Access Compliance Report

Public Rights-of-Way

Intersection ID: 27582	Main Street: BALLANTYNE_COUNTRY_CLUB_DR	Cross Street: LEDERER_AV	Location: NW
ADA ID: AF3717A0F46F	Ramp Type: BlendTrans2	Initial Pass/Fail: Fail	Overall Compliance: No
Severity Score: 12.5			
Codes/Mitigation Info/Possible Solution		Field Measurements/Component Compliance

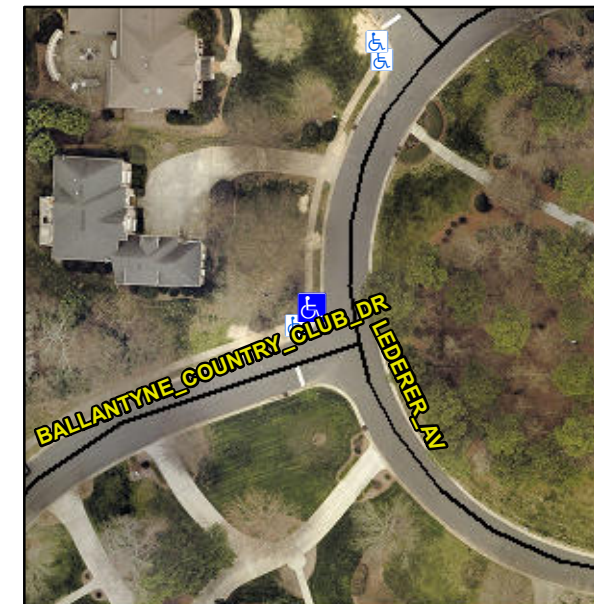
Not Found, R304.5.3

Compliance	Description	Data	Compliance	Description	Data
N/A	Ramp Length (in)	112.0	Yes	BlendTrans Slope (%)	1.9
Yes	Ramp Width (in)	48.0	No	BlendTrans XSlope (%)	5.3
N/A	Flare Type LT	N/A	N/A	Flare Type RT	N/A
N/A	Flare Slope LT (%)	N/A	N/A	Flare Slope RT (%)	N/A
N/A	Flare Traversable LT?	N/A	N/A	Flare Traversable RT?	N/A
N/A	Landing Length (in)	N/A	N/A	DWS Provided?	N/A
N/A	Landing Width (in)	N/A	N/A	DWS Contrast?	N/A
N/A	Landing Slope (%)	N/A	N/A	DWS Length (in)	N/A
N/A	Landing X Slope (%)	N/A	N/A	DWS Full Width?	N/A
N/A	Landing Curb? (Y/N)	N/A	N/A	DWS Offset (in)	N/A
N/A	Shared Landing?	N/A			
N/A	Gutter Ponding?	N/A	N/A	Gutter Slope (%)	N/A
N/A	Gutter Lip Ht (in)	N/A	N/A	Gutter X Slope (%)	N/A
N/A	Painted X Walk1?	No	N/A	Painted X Walk2?	N/A
	X Walk 1 Direction	To E		X Walk 2 Direction	N/A
	X Walk 1 Width (in)	N/A		X Walk 2 Width (in)	N/A
	X Walk 1 Slope (%)	2.1		X Walk 2 Slope (%)	N/A
	X Walk 1 X Slope (%)	5.1		X Walk 2 X Slope (%)	N/A

N/A	Ramp inside XWalk1?	N/A	N/A	Ramp inside XWalk2?	N/A
	Road Slope (%)	5.1		Clear Space?	N/A
	Road X Slope (%)	2.1	N/A	Clear Space to XWalk (in)	N/A
N/A	Any Obstructions?	N/A	N/A	Storm Grate/Utility Hazard?	N/A
	Obstruction Type			Storm Grate/Utility Type	
		N/A			N/A
			Yes	Surface Condition? (G/P)	Good
			No	Curb Slope (%)	15.6

Remove & Replace Curb Ramp With Two New Directional Ramps or Equivalent.
